POTRANCO 126.34 ACRE TRACT MASTER DEVELOPMENT PLAN

Re: Potranco 126.34 Acre Tract MDP # 805-A

The City Staff Development Review Committee has reviewed Potranco 126.34 Acre Tract Master Development Plan (M.D.P.) # 805-A. Please find enclosed a signed copy for your files. Your plan was accepted however please note the following:

COLLECTOR STREET SECTION
N.T.S.

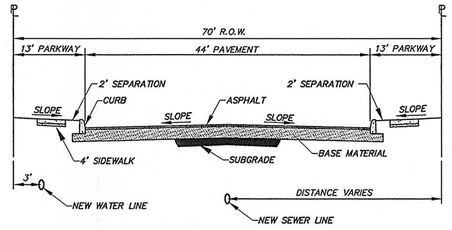
- Construction of an internal north-south collector street system approximately 500-feet in length. Collector street design parameters consist of 70-feet of ROW and 44-feet of pavement (Table 506-3). The proposed collector street shall have no houses fronting (UDC 35-515, (c), (4)).

LOCAL TYPE "B" STREET SECTION
N.T.S.

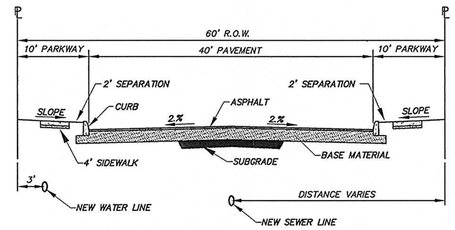
- Construction of an internal Local B collector street system approximately 2600-feet in length. Local B street design parameters consist of 60-feet of ROW and 40-feet of pavement (Table 506-3). The proposed Local B street shall have no houses fronting.

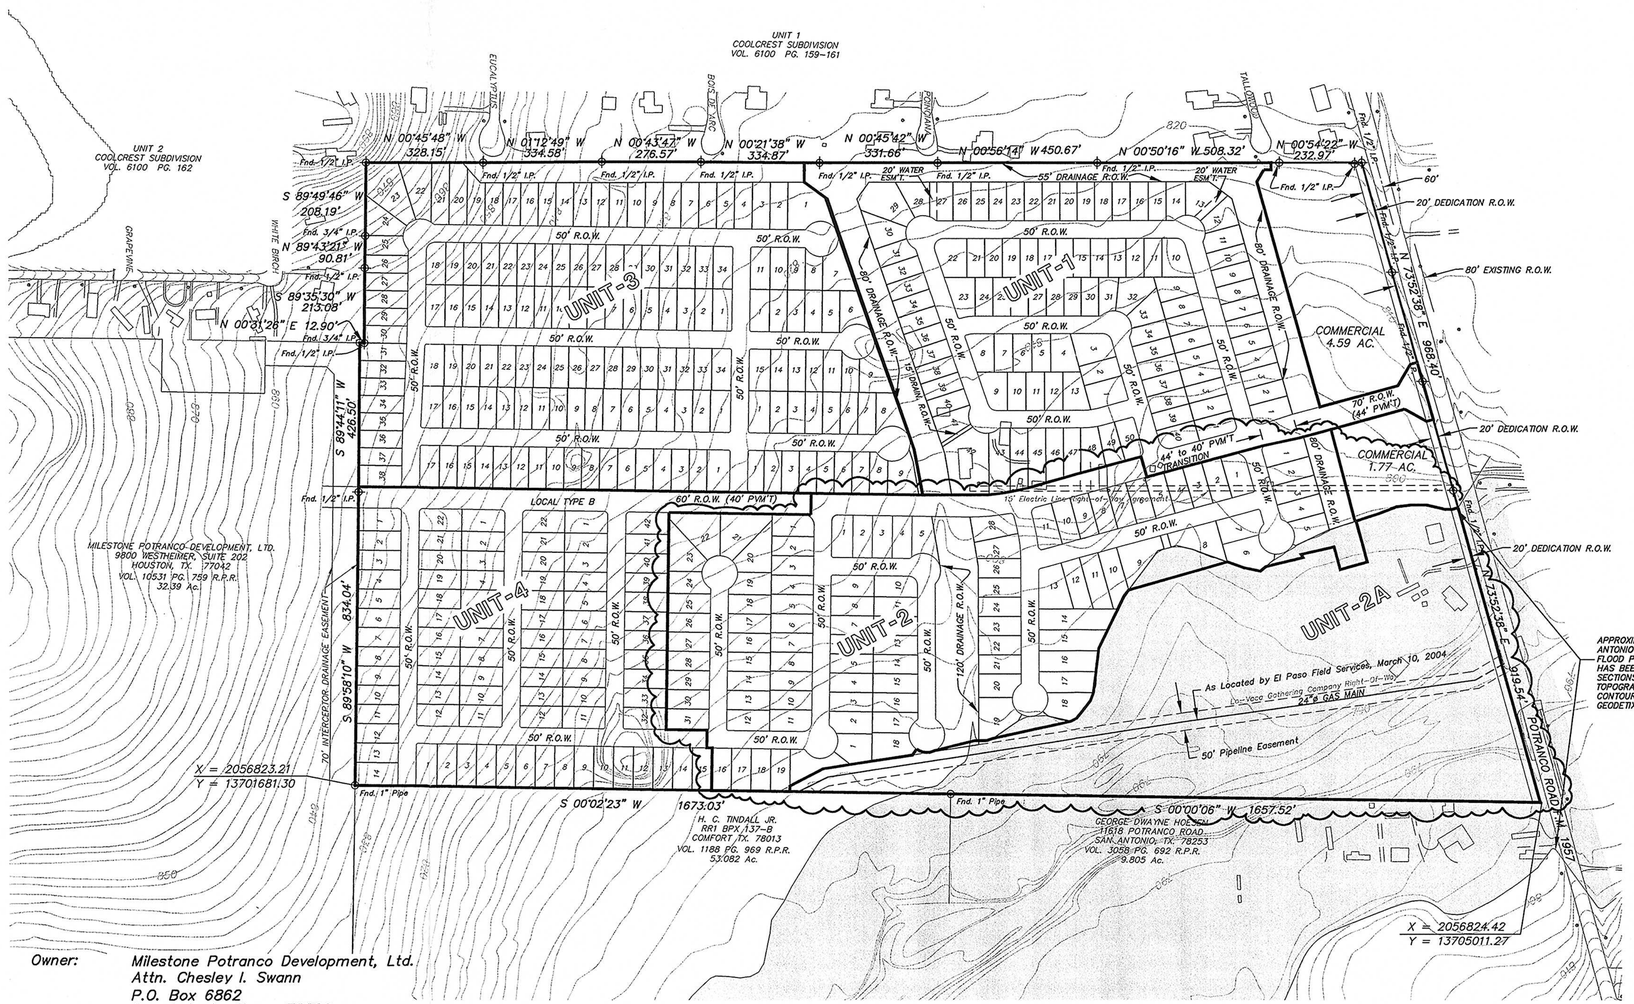
- In consideration of public safety and convenience, excessive grades by reason of topography should be avoided in street layouts and arrangements.

a. Extend the proposed northbound/southbound roadway as a collector from Potranco to the southern portion of the MDP.
     b. Provide additional pavement for left-turn lanes on collector streets intersecting other collectors.
     Extend a collector street stub-out east, approximately ½ mile south of Potranco.

1. Based upon the information provided, the above referenced MDP is approved with the following condition: add a note that addresses clear vision area requirements in accordance with 35-506(d)(5) of the UDC.
